UNITED STATES PATENT AND TRADEMARK OFFICE

APPLICATION NO.	FILING DATE	FIRST NAMED INVENTOR	ATTORNEY DOCKET NO.	CONFIRMATION NO.
10/509,190	08/09/2005	Torsten Muller	B1180/20029	5188

Office Action Summary	Application No.	Applicant(s)	
	10/509,190	MULLER ET AL.	
	Examiner	Art Unit	
	Jay R. Ripley	3679

DETAILED ACTION

(Ghosh et al Figure 1)

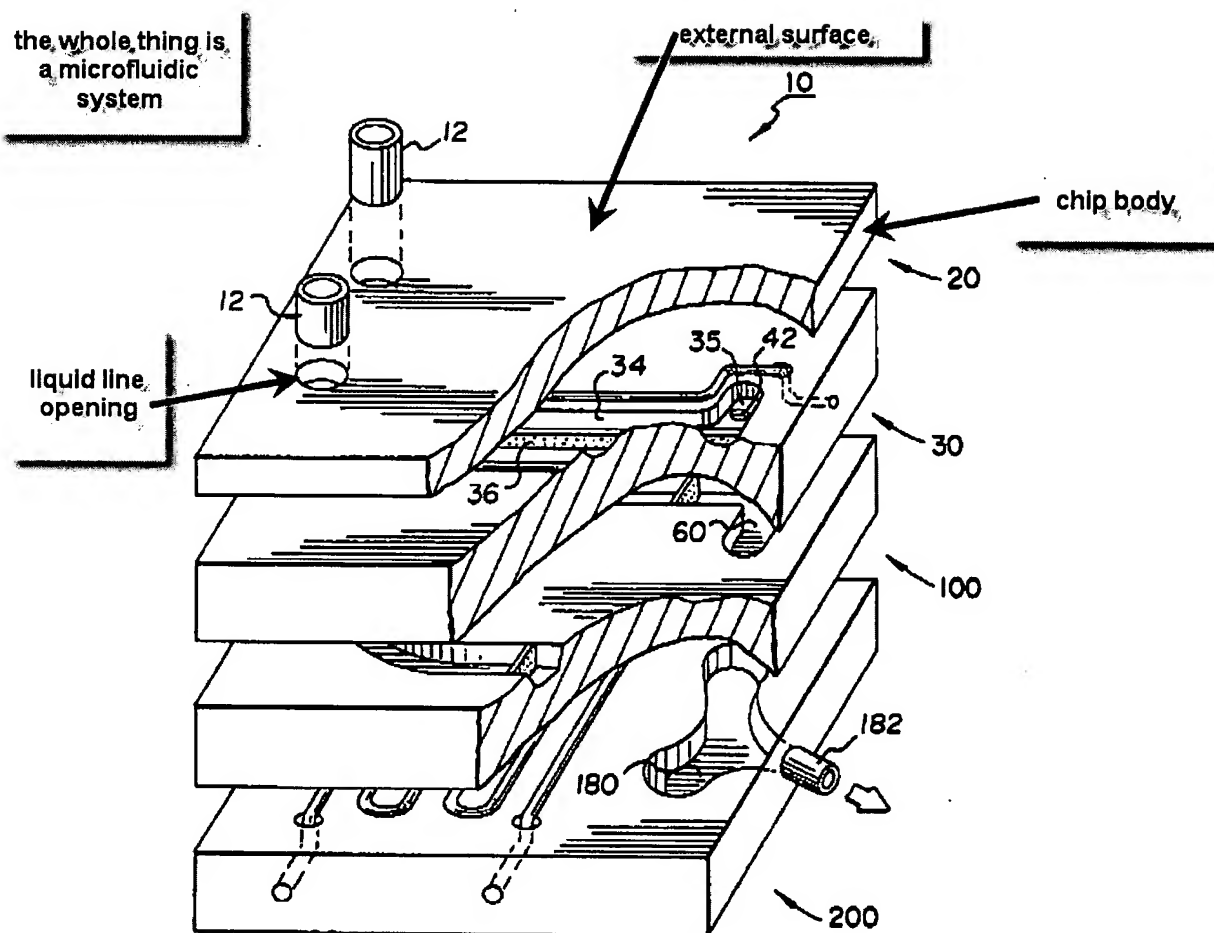
35. In regard to claim 13, Ghosh et al disclose in Figure 1, below, fluidic system (10) comprising a chip body (20).

36. In regard to claim 14, Ghosh et al further disclose in Figure 1, above, the chip body has an external surface, the external surface being planar at least in some sections and having at least one opening adjoined to a line end of the at least one liquid line.

37. In regard to claim 15, Ghosh et al further disclose in Figure 1, above, that the line end of the liquid line has a cylindrical external shape.

38. In regard to claim 16, Ghosh et al further disclose in Figure 1, above, that the fluidic system is a fluidic microsystem (The invention of Ghosh et al is a micro-chemical plant, therefore it is a fluidic microsystem).

(Fuller Figure 2)

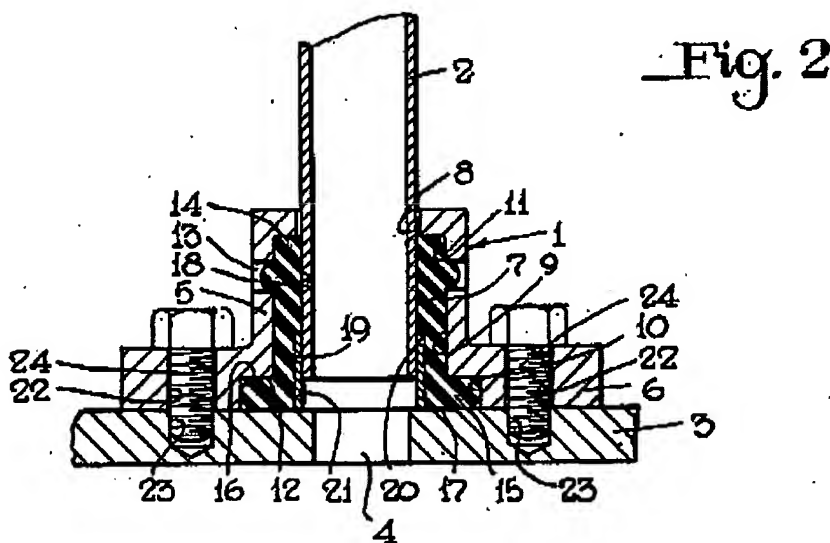
40. In regard to claim 17, Fuller disclose, in Figure 2 below, a method for liquid-tight coupling of a liquid line to a fluidic system, the method comprising:

forming a composite of at least one liquid line (2) with a bushing (7), a clamping device (1), and a fluidic system (3 is the wall of the system), and

actuating the clamping device to produce a contact pressure on a projection of the bushing (column 3, lines 12-30) in such a way that the sealing device forms the liquid-tight connection with the external surface of the fluidic system.
